Clarification on Handling Unconnected V_{CCINT} Pins for Virtex Devices

PCN2004-12 (v1.0) August 9, 2004

Product/Process Change Notice - FYI

Figure 1 - Package top-mark example

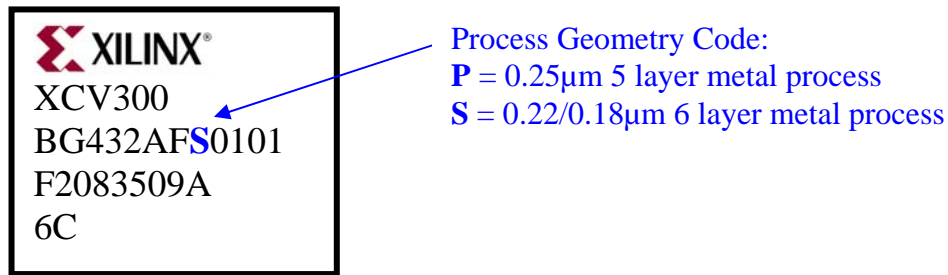
Virtex devices manufactured on the 0.25µm 5-layer metal process are designated with a process geometry code of "P". Virtex devices manufactured on the 0.22/0.18µm 6-layer metal process are designated with a process geometry code of "S". The Virtex devices with process geometry code of "S" contain the internal V_{CCINT} package plane.

Figure 1 shows package top-mark example and the location of the process geometry code.
